Arboricultural Consultation Response

Application No: 25/00943/HHFUL	**Location:** Ganymede, High Haden Road, Glatton, Huntingdon, PE28 5RU
Case Officer: JFR	**Proposals:** Outbuilding to form garden room, store and home gym

The Mapping and Tree Protection Plan now provided, clearly shows the Arboriculutral impact that the development would have:

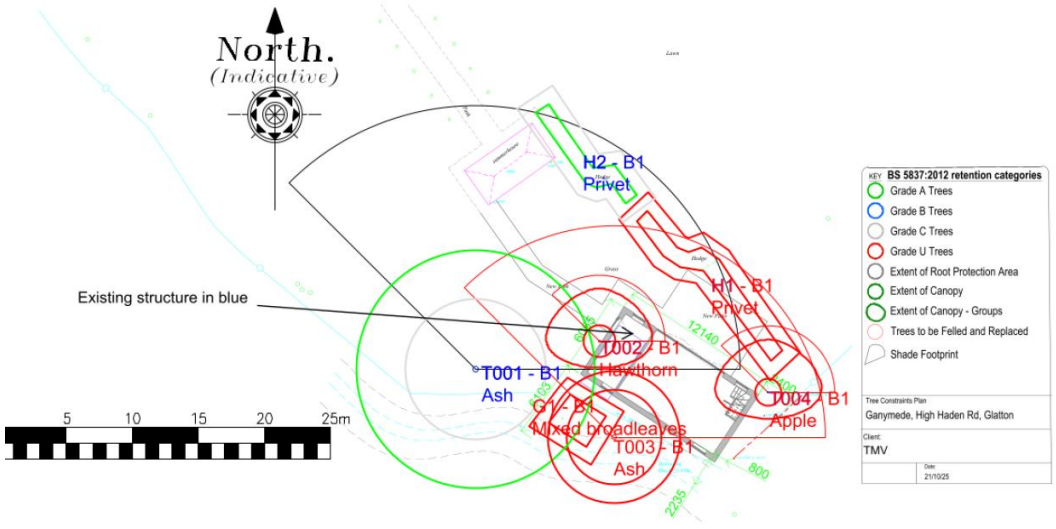
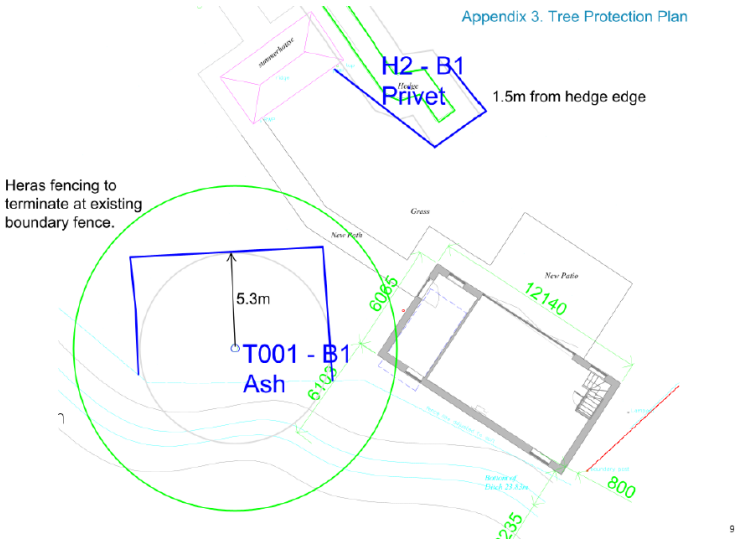
Category A and B trees should be retained during development – please see LP30 and 31 detailed above. This proposal now makes clear that it would involve the removal of T2, T3 T4, G1 and H1.

This represents most of the canopy cover in this area and would impact the larger group of trees running along the side of the property as a visual/landscape feature (see below).

The location of the development then means that the summerhouse is located immediately to the northern side of what should be a tree belt. Shading is therefore likely to be an on-going issue. The images above show that the thin line of trees in the south westerly corner of the property would most likely be broken, and the building visible from the wider landscape.

Recommendation: Refuse Application – The impact of the development is significant, and I would recommend that it is relocated away from the existing trees to allow their retention. This would solve all of the existing issues.
